ADDENDUM 1
RFB #17-0038
RONALD REAGAN BUILDING RENOVATION-FLOORS 4,5,6

**RONALD REAGAN BUILDING RENOVATION – FLOORS
4,5,6
Sedgwick County**

Prepared by:
Schaefer Johnson Cox Frey Architecture, Inc.

1. LEVEL 5 FLOOR PLAN
1/8" = 1'-0"

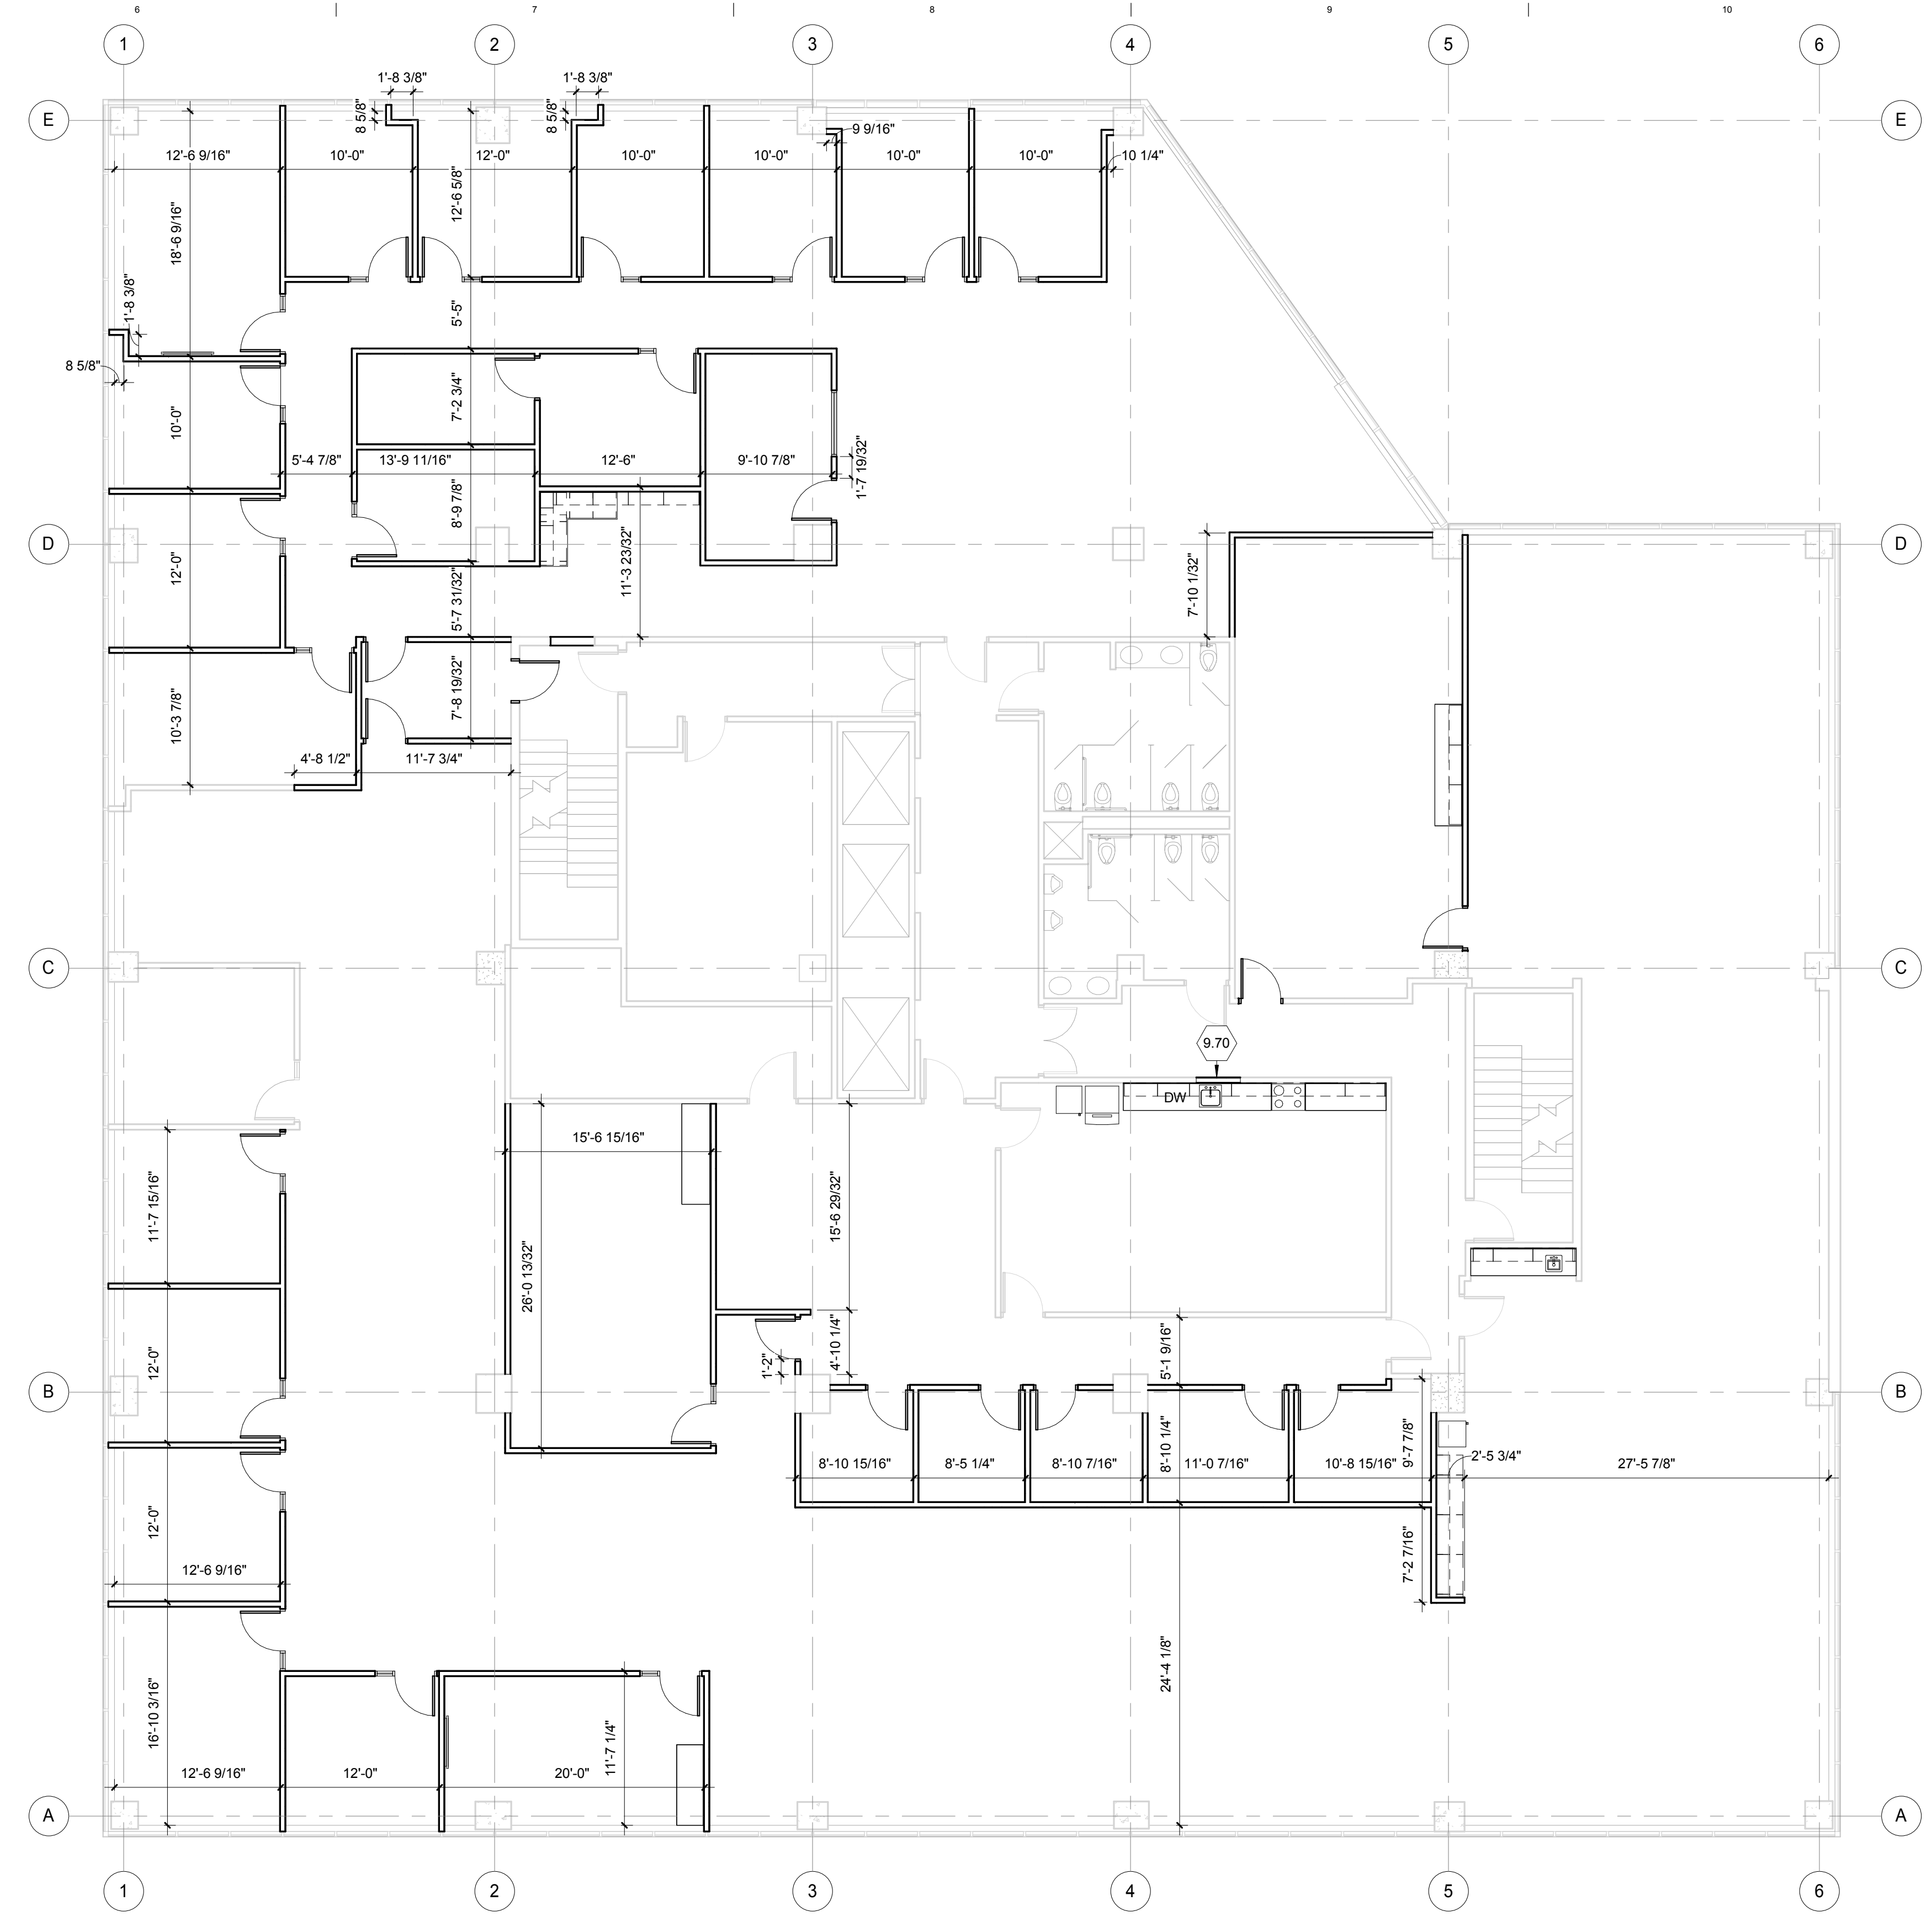
ITEM AD1-A04 DRAWING SHEET A22.1, KEYED NOTES:
REVISION Replace Keyed Note list per attached.

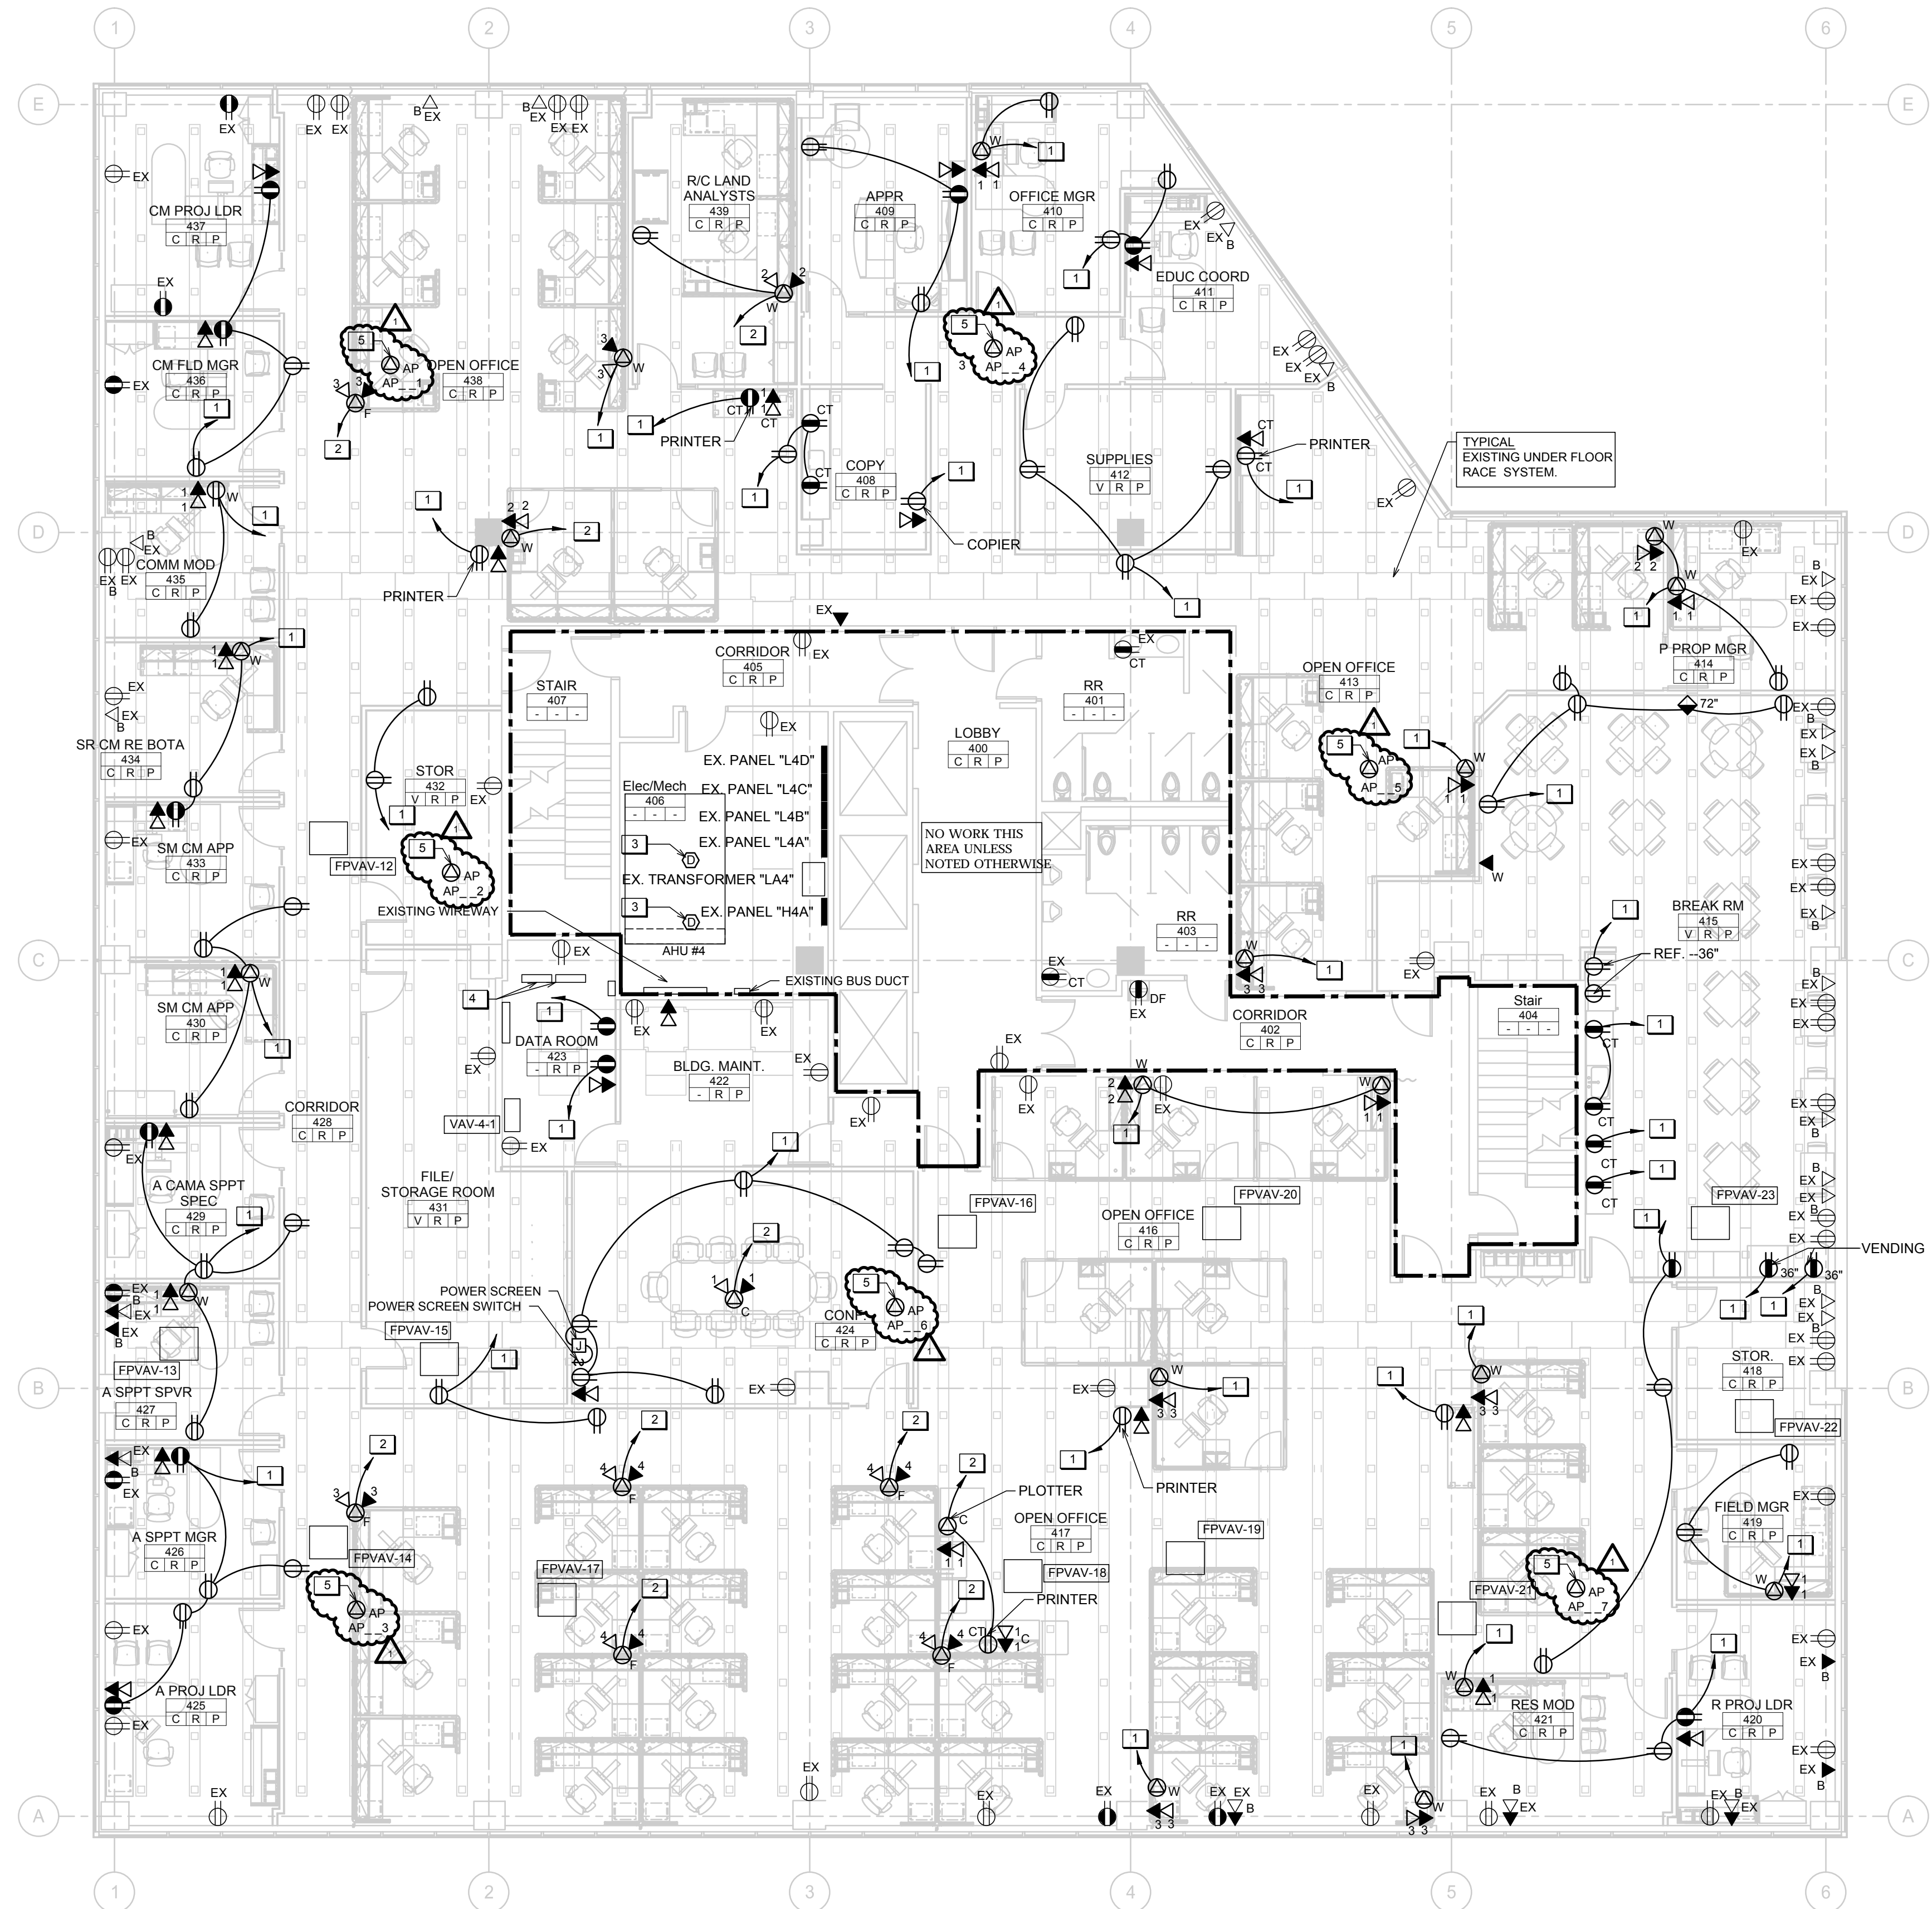
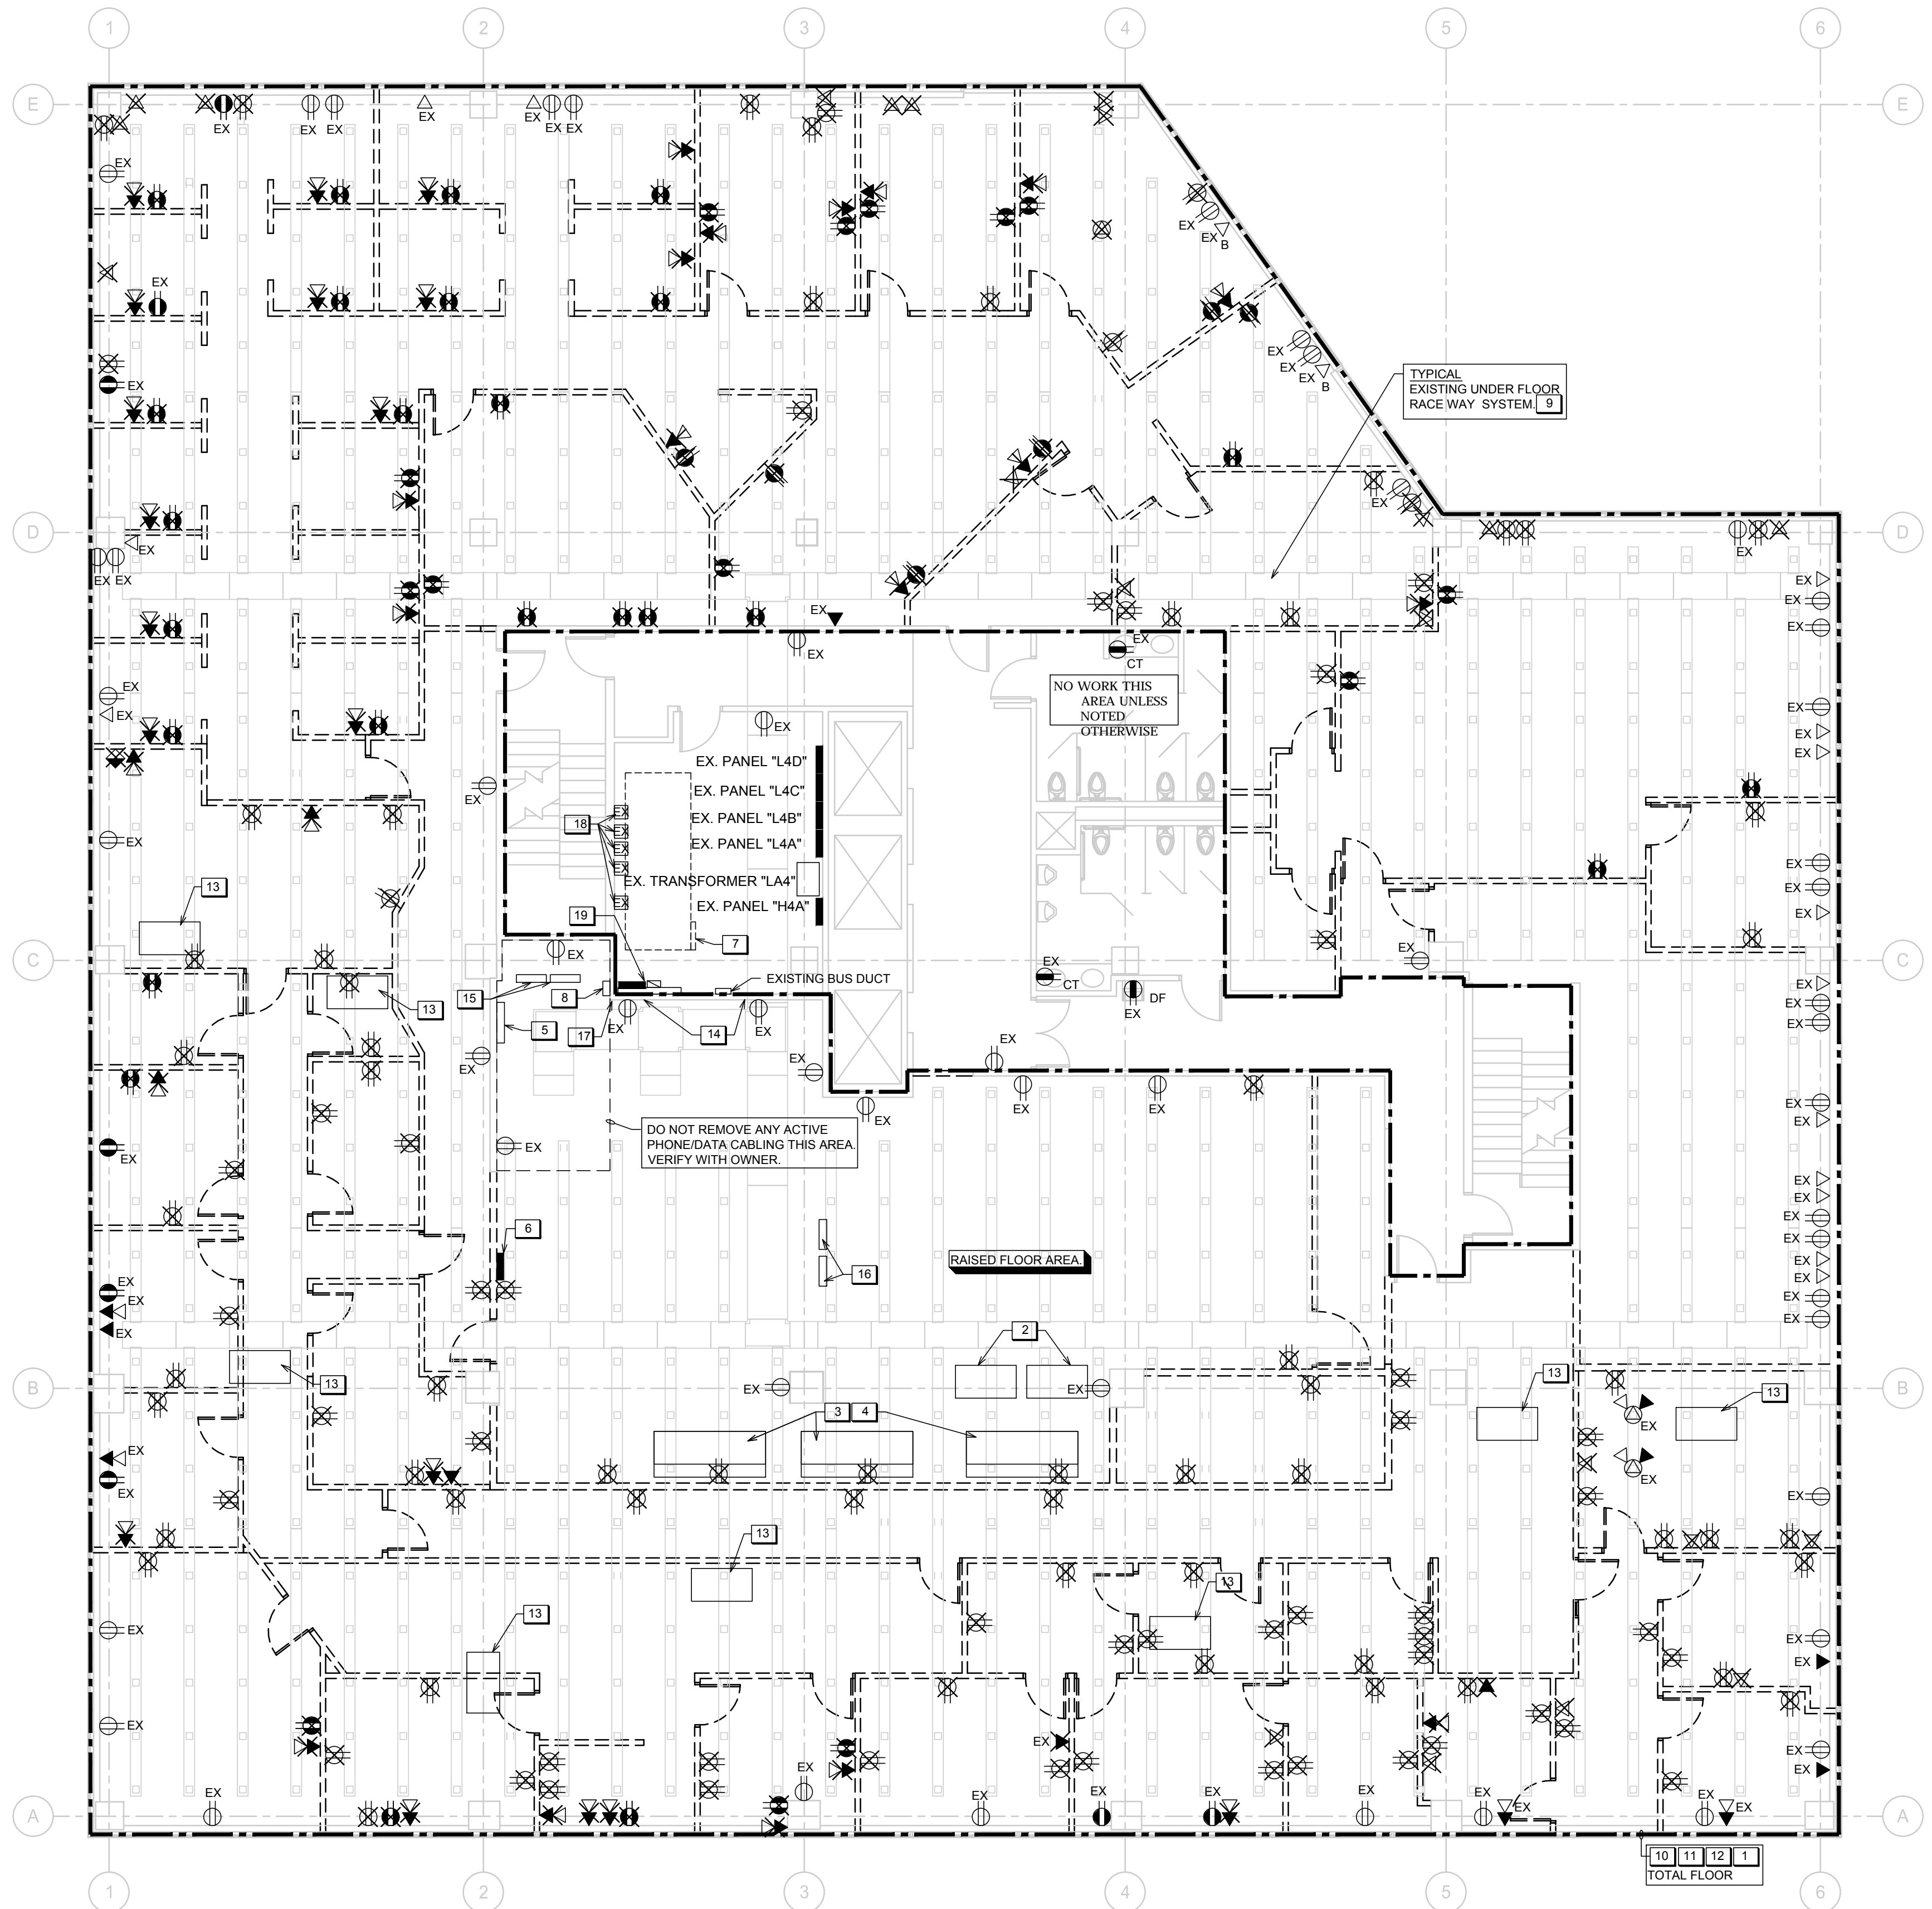
- 50 **ITEM AD1-A17** DRAWING SHEET A21.1, KEYED NOTES:
DELETION Keyed Note 8.17: Delete this keyed note.
- 55 **ITEM AD1-A18** DRAWING SHEET A22.2, KEYED NOTES:
REVISION Keyed Note 11.21: Revise to read "Mobile filing system and plywood infill
by Owner. Contractor to provide carpet tile over plywood between tracks."

- 11.21 MOBILE FILING SYSTEM AND PLYWOOD INFILL BY OWNER. CONTRACTOR TO PROVIDE CARPET TILE OVER PLYWOOD BETWEEN TRACKS.
- 11.23 OVER RANGE FURNISHED BY OWNER AND INSTALLED BY CONTRACTOR. MAX. TOTAL LOAD CAPACITY TO BE 12KW.
